**Re: A006875508 - 58 Rogers Parade W Everton Park**

**Council Ref:** A006875508 – Development application for Reconfiguring a Lot (1 into 6 lots) & access easement

**Location:** 58 Rogers Parade West, Everton Park, QLD, 4053 – Lot 634 on SL11121

**Subject:** Update to submission objecting to a development application pursuant to Section 53 of the *Planning Act 2016*

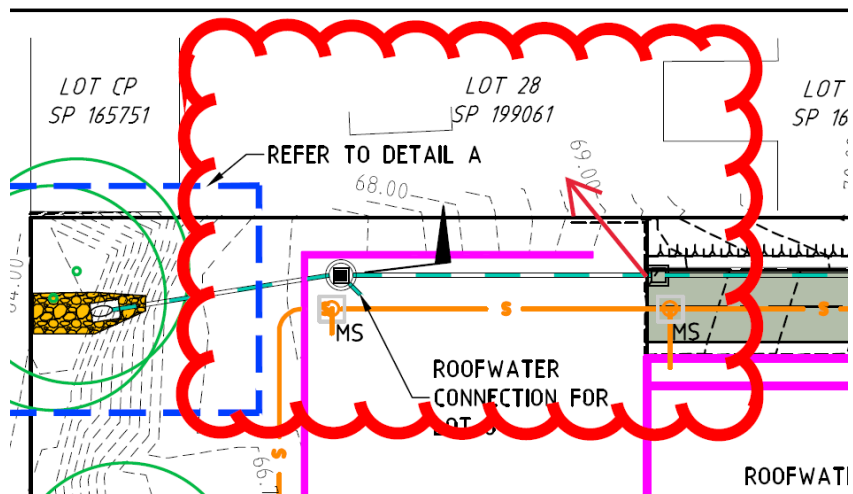
The revised drawings do not provide enough details or levels to indicate how the stormwater in a major flow event would continue to pass into proposed Lot 6 and then to the existing waterway, as the kerb on the driveway finishes at the boundary of Lot 6 and no details or levels have been provided at the end of the driveway to show how stormwater would not be concentrated onto Lot 28 on SP199061. Please refer to the red arrow on the figure below:

We request that more detailed information is provided at this location to show that stormwater will not be concentrated towards Lot 28 on SP199061.

We believe that a cut-off drain or swale may be required between the proposed retaining wall for Lot 6 and the boundary with Lot 28 on SP199061 to ensure that stormwater from the driveway would be directed to the waterway at the rear of the application site.
